Access Compliance Report

Public Rights-of-Way

Intersection ID: N/A	Main Street: SHARON_RD	Cross Street: BRONSON_DR	Location: N
ADA ID: 51F73CF29F48	Ramp Type: PerpDiag	Initial Pass/Fail: Fail	Overall Compliance: No
			Severity Score: 13.75

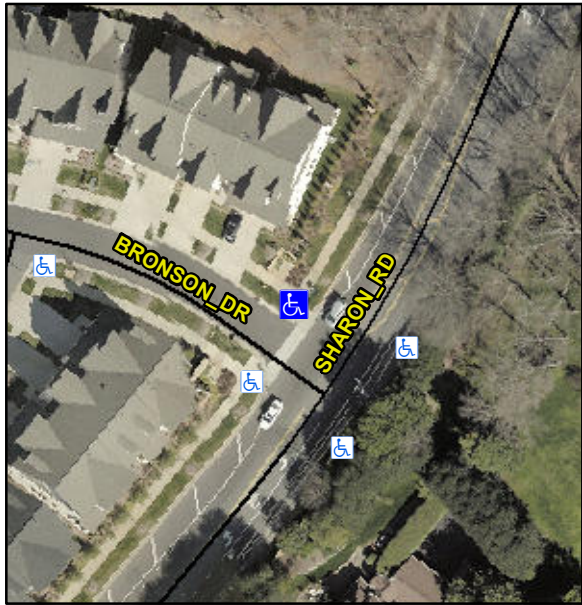
Codes/Mitigation Info/Possible Solution			Field Measurements/Component Compliance					
	Possible Solutions:		Compliance	Description	Data	Compliance	Description	Data
	Remove & Replace Curb Ramp With Two New Directional Ramps or Equivalent.		N/A	Ramp Length (in)	96.0	No	Ramp Slope (%)	10.5
			Yes	Ramp Width (in)	60.0	No	Ramp XSlope (%)	3.9
			N/A	Flare Type LT	N/A	N/A	Flare Type RT	N/A
			N/A	Flare Slope LT (%)	N/A	N/A	Flare Slope RT (%)	N/A
			N/A	Flare Traversable LT?	N/A	N/A	Flare Traversable RT?	N/A
			N/A	Landing Length (in)	N/A	N/A	DWS Provided?	N/A
			N/A	Landing Width (in)	N/A	N/A	DWS Contrast?	N/A
			N/A	Landing Slope (%)	N/A	N/A	DWS Length (in)	N/A
			N/A	Landing X Slope (%)	N/A	N/A	DWS Full Width?	N/A
Surveyor Notes:			N/A	Landing Curb? (Y/N)	N/A	N/A	DWS Offset (in)	N/A
N/A			N/A	Shared Landing?	N/A			
PROW/ADA:			N/A	Gutter Ponding?	N/A	N/A	Gutter Slope (%)	N/A
Not Found, R304.2.2, R304.5.3			N/A	Gutter Lip Ht (in)	N/A	N/A	Gutter X Slope (%)	N/A

N/A	Painted X Walk1?	No	N/A	Painted X Walk2?	No
				X Walk 1 Direction	To SW		X Walk 2 Direction	To SE
			N/A	X Walk 1 Width (in)	N/A	N/A	X Walk 2 Width (in)	N/A
				X Walk 1 Slope (%)	0.4		X Walk 2 Slope (%)	3.8
				X Walk 1 X Slope (%)	4.2		X Walk 2 X Slope (%)	0.3
			N/A	Ramp inside XWalk1?	N/A	N/A	Ramp inside XWalk2?	N/A
				Road Slope (%)	0.8	N/A	Clear Space?	N/A
				Road X Slope (%)	1.6	N/A	Clear Space to XWalk (in)	N/A
			N/A	Any Obstructions?	N/A	N/A	Storm Grate/Utility Hazard?	N/A
				Obstruction Type			Storm Grate/Utility Type	
					N/A			N/A
						Yes	Surface Condition? (G/P)	Good
Total Cost:		\$ 3200.00
